# METROPOLITAN GOVERNMENT OF NASHVILLE AND DAVIDSON COUNTY

## STAFF RECOMMENDATION 948 Seymour Avenue November 14, 2012

**Application:** Demolition; New construction – primary building

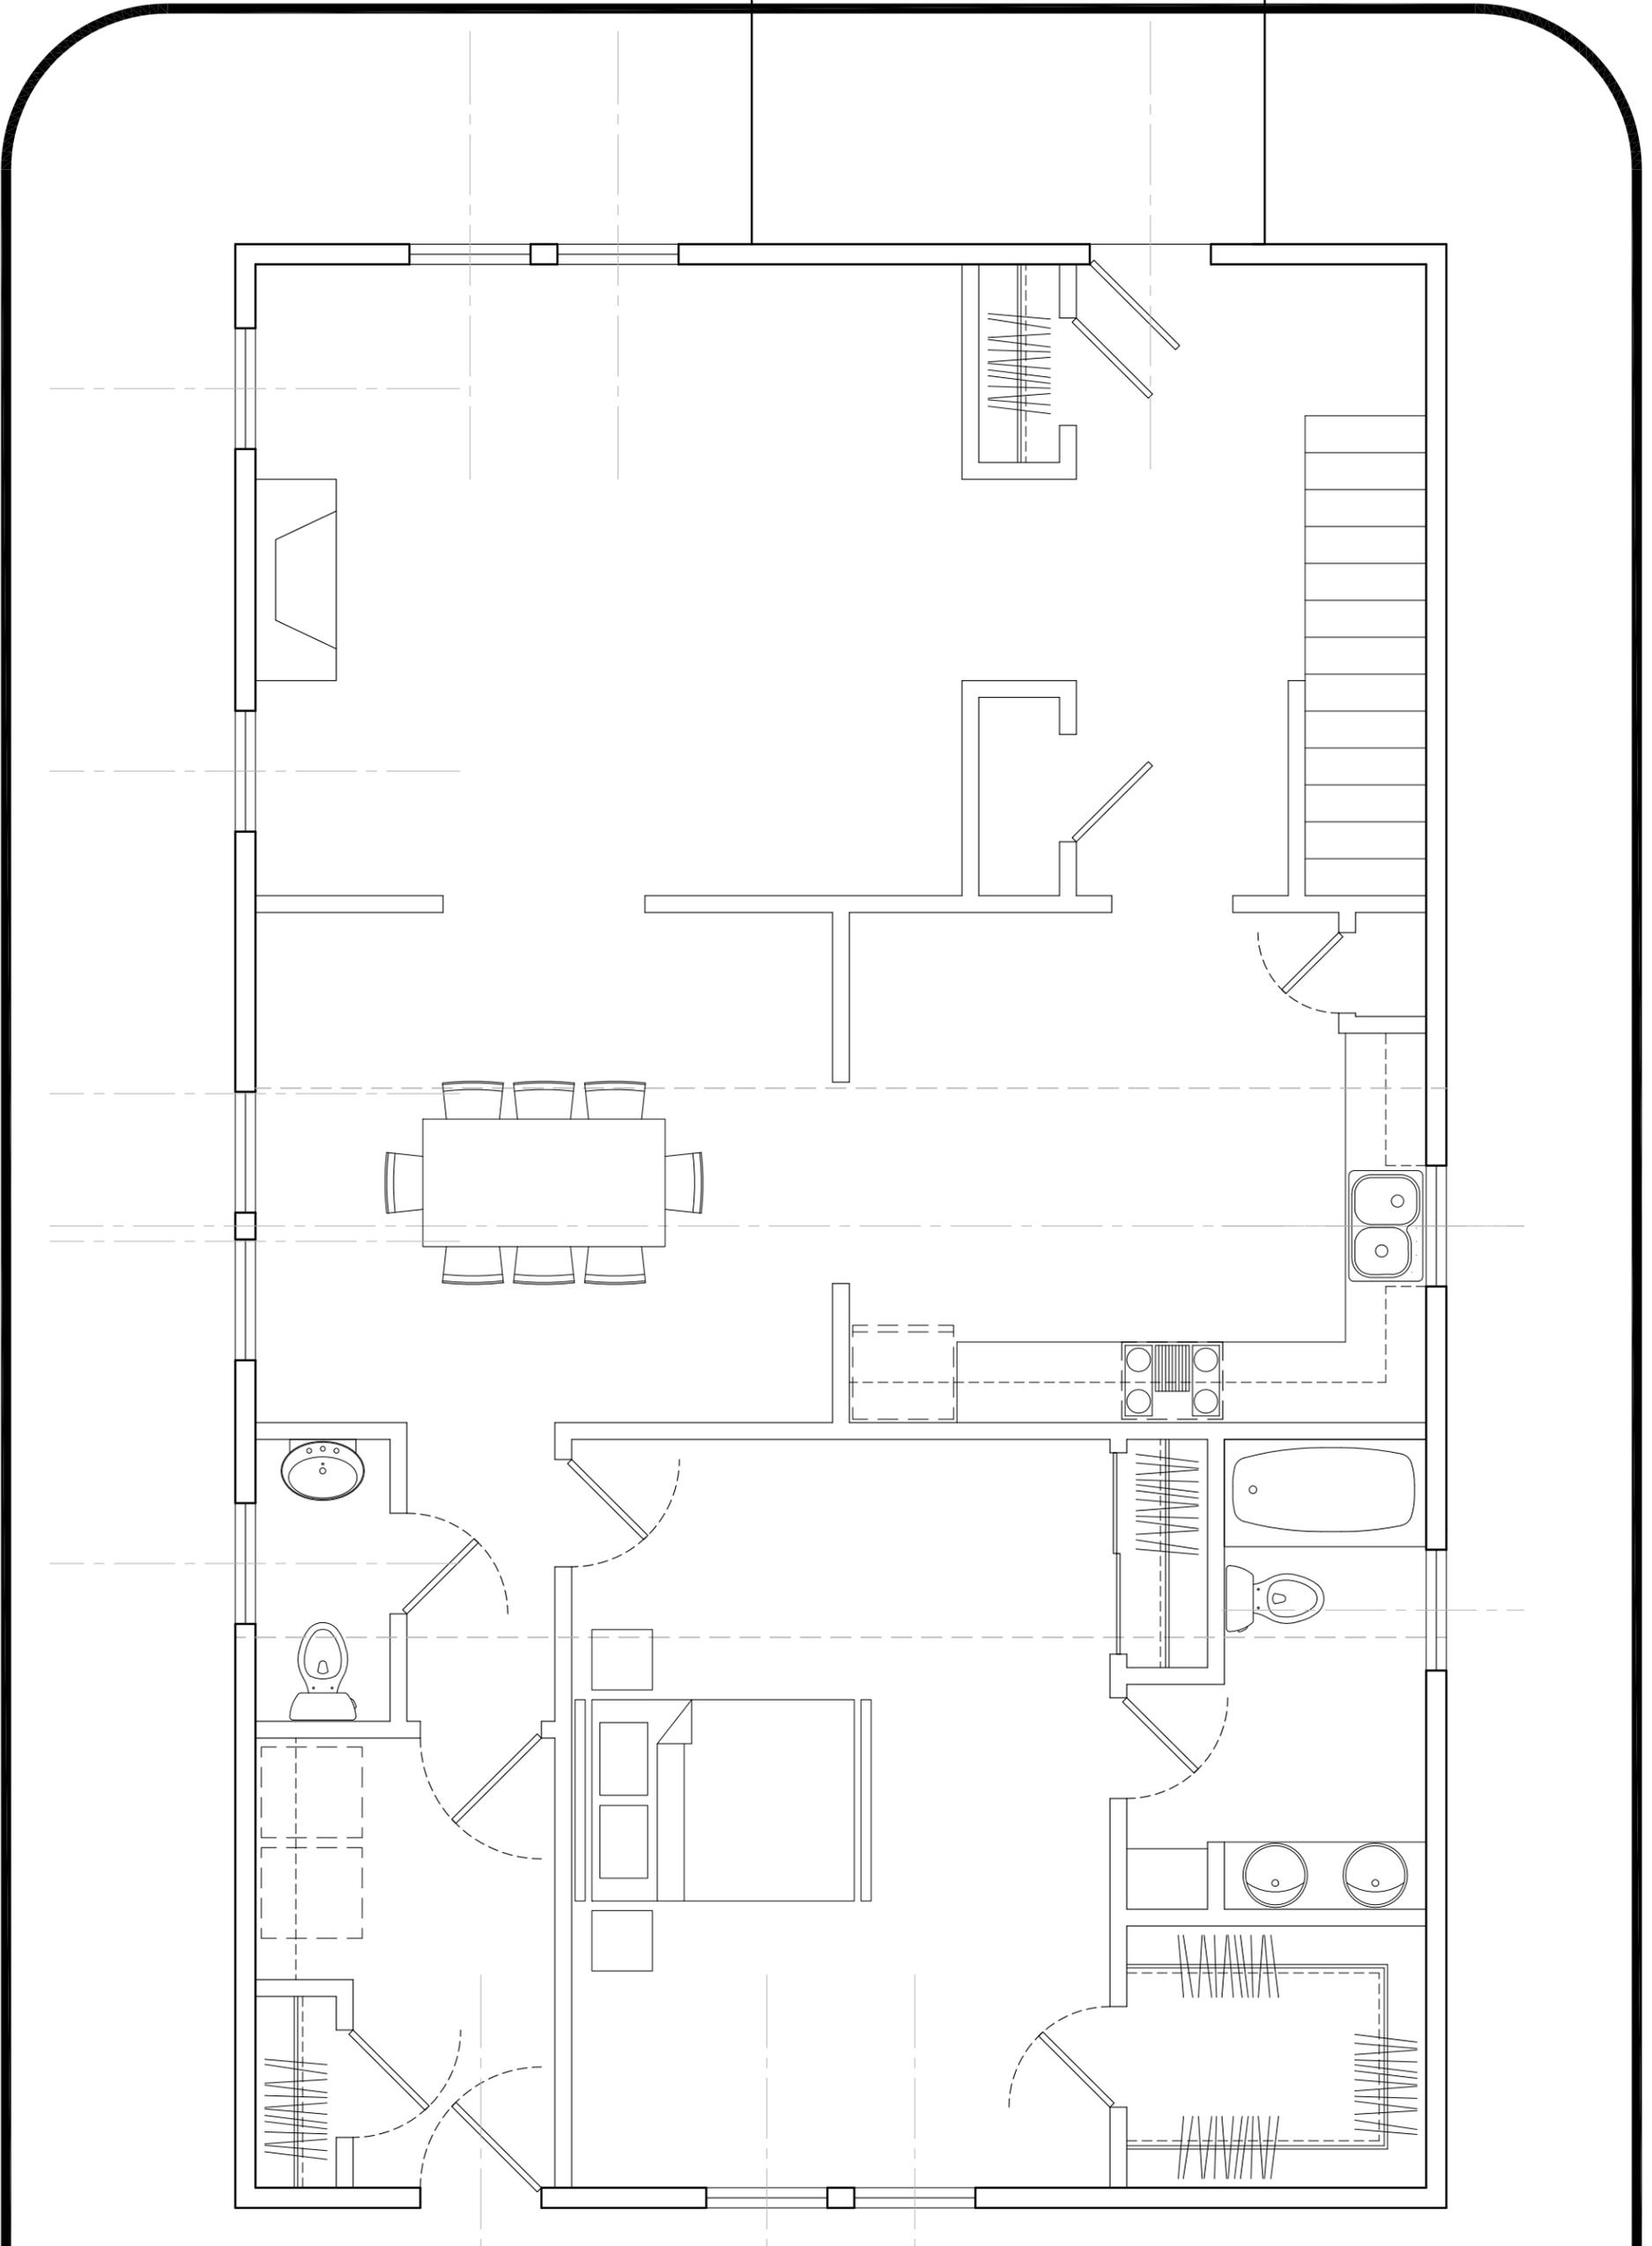
To avoid discrepancies during construction, major measurements should be called out on the site plan and elevations prior to receiving a permit.

The new house will reuse the foundation of the existing non-contributing structure, if possible. The front setback of the existing building matches the adjacent historic house and other historic houses on the street, and the side setbacks are similar to those of surrounding historic houses and will maintain the rhythm of the street established by historic houses. Staff finds the setbacks to be appropriate and to meet guideline II.B.1.c.

**1 NORTH ELEVATION**

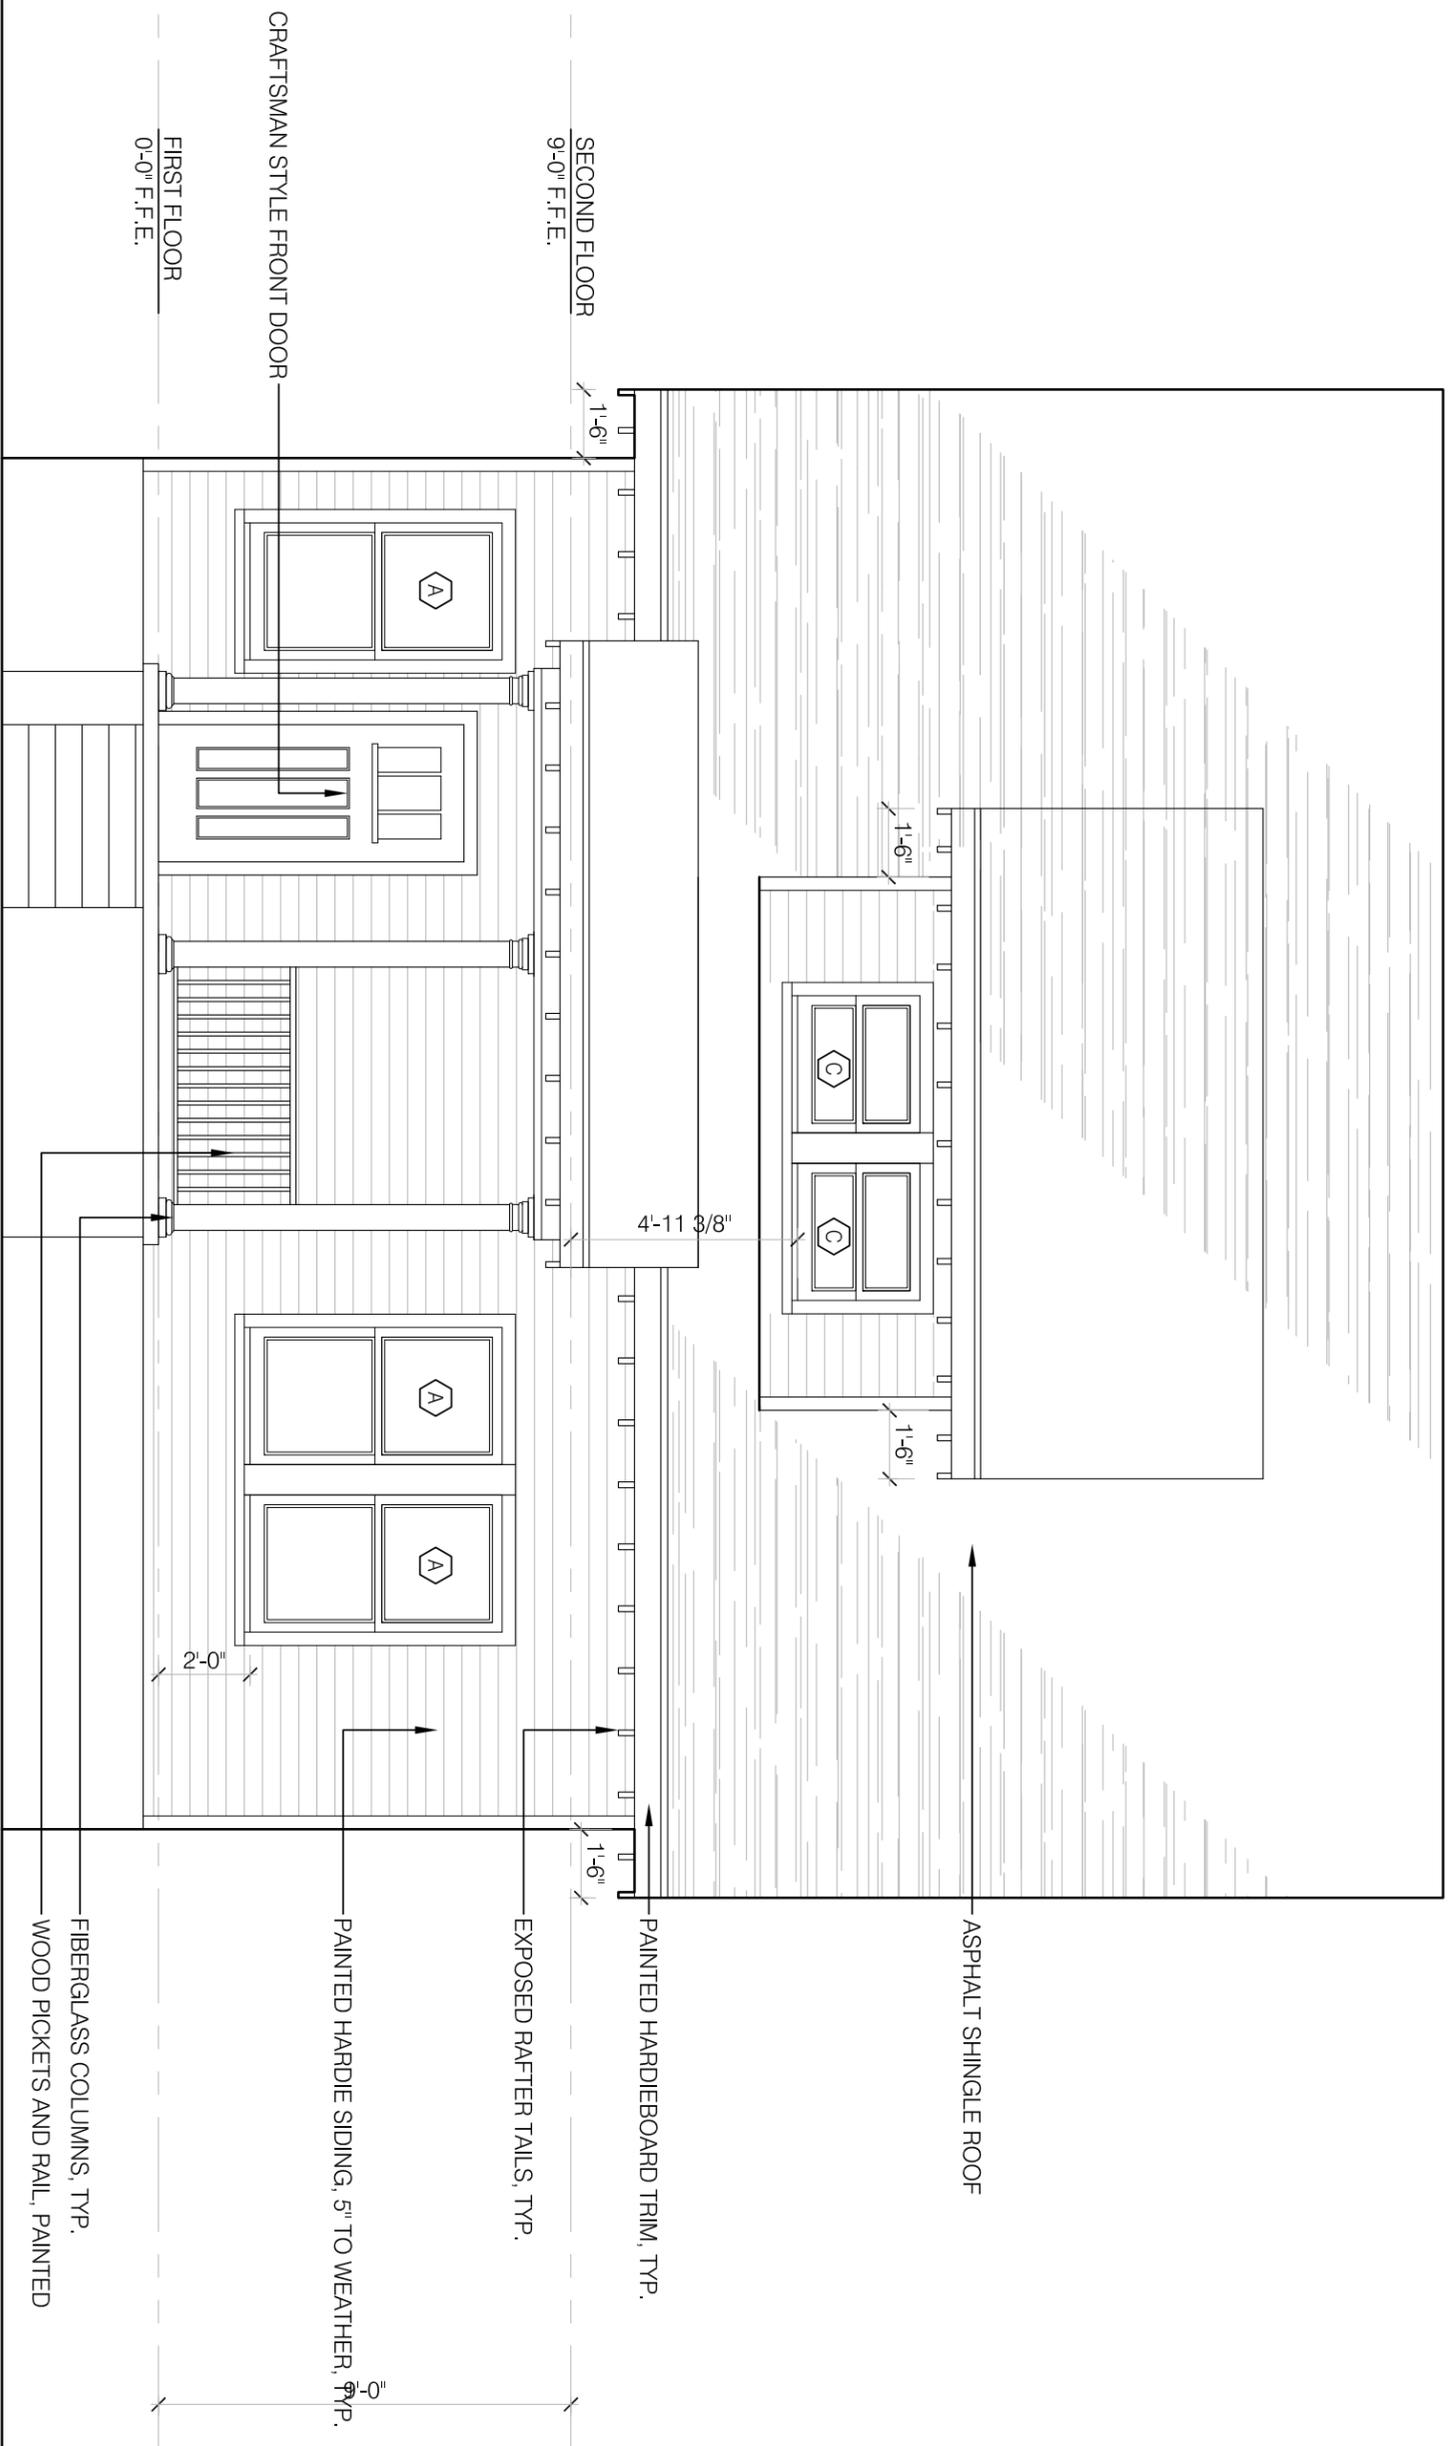
The front elevation will have two bays, with a pair of windows on the right side and a door and one window on the left bay. Asymmetry is not uncommon for historic houses in the district, many of which have partial-width porches on one side. The right façade will have multiple openings with no more than six feet (6") between them in the front two-thirds (2/3) of the lower-story wall. The left elevation, however, would have more than twenty-two feet (22') of unpunctuated wallspace forward of a window in the center of the lower-story wall. This would not be compatible with the rhythm of windows seen on historic houses.

On the upperstory, both the left and right elevations show a pair of windows centered in the walls. In the front dormer there will be a pair of windows, with more than two feet (2') of wall on either side. Typically, dormers in windows fill nearly the entire front wall where as these fill less than two-thirds (2/3).

With the addition of at least one opening in the front section of the left elevation and openings filling the front wall of the dormer, Staff finds that the window rhythm would meet guideline II.B.1.g.

1. Major measurements should be called out on the site plan and elevations;
2. The existing foundation should be parge coated if retained;
2. If a new foundation be required, it should be split-faced concrete block;
3. Additional information is submitted and approved by staff for the windows and roof color;
4. An additional window or opening should be added to the left elevation in the front third (1/3) of the lower-story wall; and
5. The front dormer should have windows filling the entire front wall.
